FIRE SAFETY INSPECTION REPORT

LZ TEXTILES LTD

ACCORD ID: 12112

February 6, 2015

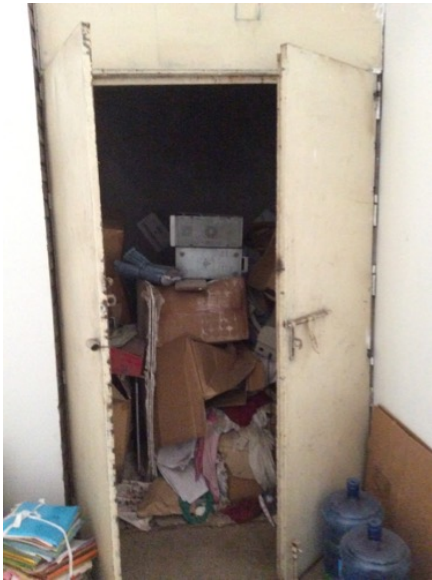
F-2	Fire Rated Construction	Rooms used for combustible storage are not separated by fire-rated construction. This pertains to the west side of the factory on the ground floor. The storage rooms are not properly separated from the egress corridor that serves them. For example, see open soffits at the top of the storage room walls in attached photo.	Provide dedicated storage rooms separated by minimum 1-hr fire-rated construction. Where separate storage rooms are not feasible, provide defined storage areas and limit the storage arrangement as follows: - Maximum height of 2.45m (8ft.) and maximum area of 23m² (250 ft²) - If sprinkler protected: maximum height of 3.66m (12ft.) and maximum area of 93m² (305ft²) Separate areas of unenclosed combustible storage by a minimum clear distance of 3m (10ft.).	Within 3 months
-----	-------------------------	---	--	-----------------
